Note on the modifications to the special WRP-16 card

WRP-16 Warm Receiver & Power 16 Channel

Figure 2. Modified pair of regulator circuits on the special WRP-16 card.

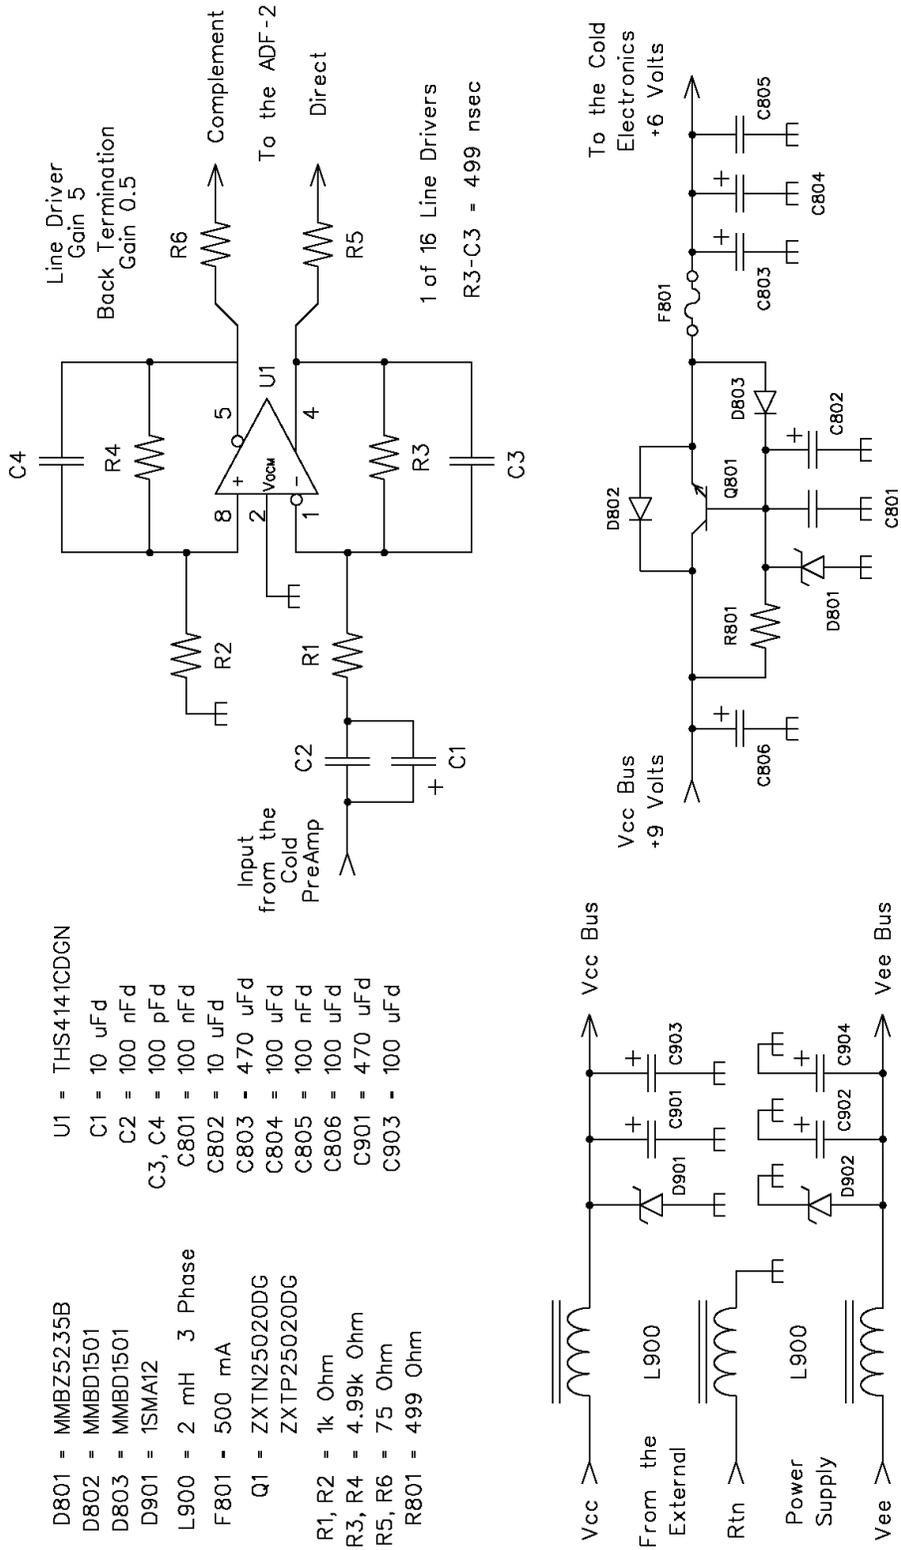
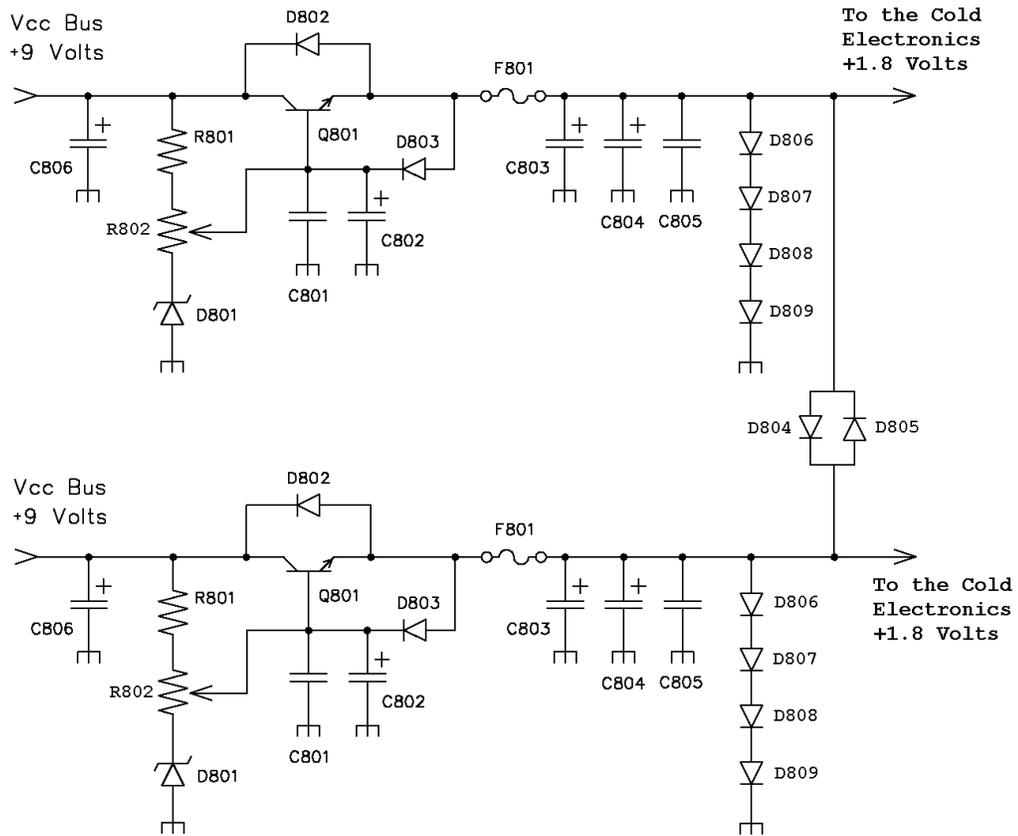
This modification to the special WRP-16 card changes the output voltage of two of the on-board regulator circuits from the typical 6 Volt value to 1.8 Volts. Figure 1 shows the schematic for the unmodified WRP-16, and Figure 2 shows the unique details of the special WRP-16 card.

(1) Change Zener diode D801 to a part with a different Zener voltage and add variable resistance R802.

(2) Add diodes D806 through D809 to each modified regulator. This series of forward-biased diodes will go into increasing conduction if the regulated voltage increases above the nominal 1.8 volts. In the case of a regulator failure which drives the regulated voltage above 2.3 volts, the diode array will conduct in excess of 500 mA, which will blow fuse F801. F801 is rated at 500 mA and the diodes have continuous current ratings of 1 Amp (1N4001) and 3 Amps (1N5820). This circuit element is added to protect the voltage-sensitive ASIC preamp card inside the LAPD cryostat.

(3) Add diodes D804 and D805 to ensure that the two voltages from the modified regulators will remain within one diode drop of each other. D804 and D805 have a continuous current rating of 1 Amp. This circuit element was added to protect the ASIC preamp chip inside the LAPD cryostat from being powered on only one of its two voltage inputs.

(4) Remove F801 from the two voltage regulators that are not used on the special WRP-16.

Part changes relative to unmodified
WRP-16 regulator circuit

D801 = MMBZ5223B-7-F
D804, D805, D806, D807 = 1N4001
D808, D809 = 1N5820
R802 = 500 Ohm trimmer
